Access Compliance Report

Public Rights-of-Way

Intersection ID: 21797	Main Street: GALLERIA_BV	Cross Street: MONROE_RD	Location: NW
ADA ID: CDCC1390CCD1	Ramp Type: Perp	Initial Pass/Fail: Fail	Overall Compliance: No
Severity Score: 33.75			
Codes/Mitigation Info/Possible Solution		Field Measurements/Component Compliance

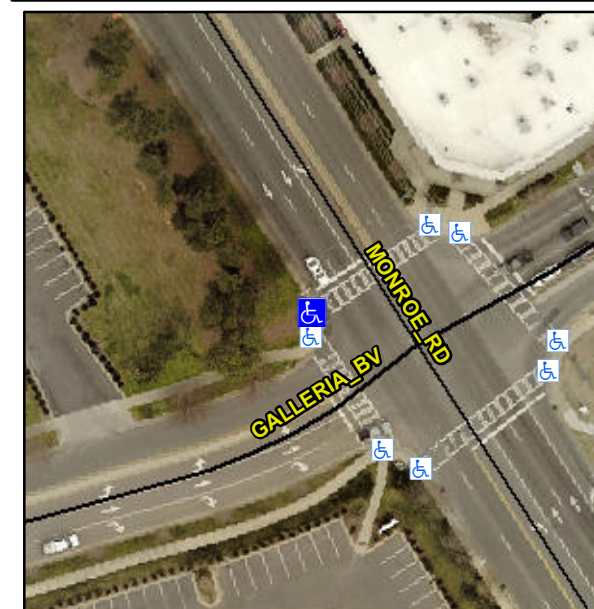
R304.5.1, R304.2.2, R304.5.3

Compliance	Description	Data	Compliance	Description	Data
N/A	Ramp Length (in)	36.0	No	Ramp Slope (%)	8.4
No	Ramp Width (in)	40.0	No	Ramp XSlope (%)	5.8
N/A	Flare Type LT	N/A	N/A	Flare Type RT	N/A
N/A	Flare Slope LT (%)	N/A	N/A	Flare Slope RT (%)	N/A
N/A	Flare Traversable LT?	N/A	N/A	Flare Traversable RT?	N/A
N/A	Landing Length (in)	N/A	N/A	DWS Provided?	N/A
N/A	Landing Width (in)	N/A	N/A	DWS Contrast?	N/A
N/A	Landing Slope (%)	N/A	N/A	DWS Length (in)	N/A
N/A	Landing X Slope (%)	N/A	N/A	DWS Full Width?	N/A
N/A	Landing Curb? (Y/N)	N/A	N/A	DWS Offset (in)	N/A
N/A	Shared Landing?	N/A			
N/A	Gutter Ponding?	N/A	N/A	Gutter Slope (%)	N/A
N/A	Gutter Lip Ht (in)	N/A	N/A	Gutter X Slope (%)	N/A
N/A	Painted X Walk1?	Yes	N/A	Painted X Walk2?	N/A
	X Walk 1 Direction	To NE		X Walk 2 Direction	N/A
N/A	X Walk 1 Width (in)	96.0	N/A	X Walk 2 Width (in)	N/A
	X Walk 1 Slope (%)	5.4		X Walk 2 Slope (%)	N/A
	X Walk 1 X Slope (%)	0.5		X Walk 2 X Slope (%)	N/A

Remove & Replace Entire Ramp.
